GOVERNMENT OF INDIA
MINISTRY OF RAILWAYS
RESEARCH DESIGNS AND STANDARDS ORGANISATION

MODIFICATION SHEET NO. RDSO/WA44/99

MODIFICATION TO ELGI PNEUMATIC PRESSURE SWITCHES
FOR MINIMISING DIAPHRAGM FAILURE

SKEL 3267

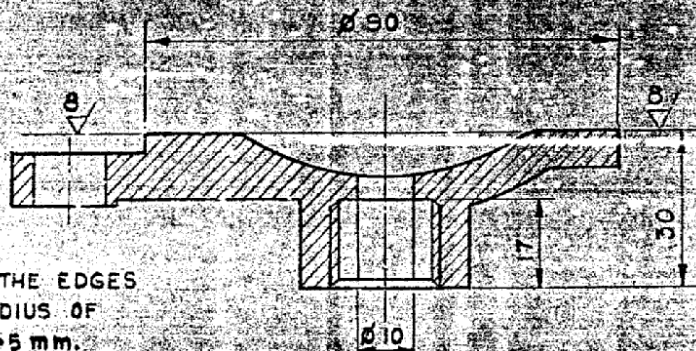
- 1 a) Machine the seating surface for the diaphragm in the bottom flange as shown in drg. No. SKEL 3267 to a fine finish with minimum cut.
- b) Finish the edges where central cavity and diaphragm seat meet to a radius of 1.0 to 1.5 mm.
- 1.4) Replace the existing rubber diaphragm with fabric reinforced polychloroprene rubber conforming to dimensions and specification given in drg. No. SKEL 3260.

FINISH THE EDGES
TO A RADIUS OF
1.0 TO 1.5 mm.

SKEL 3260

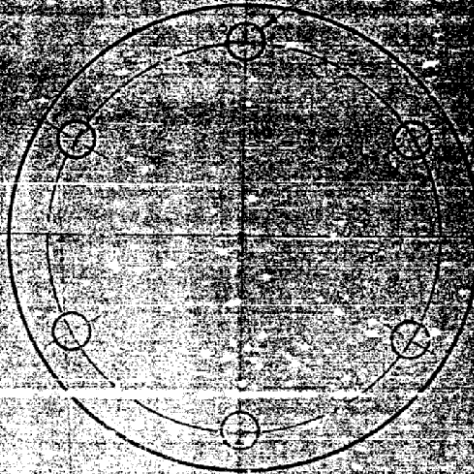
i) One fabric reinforced PCP diaphragm conforming to drg. No. SKEL 3260.
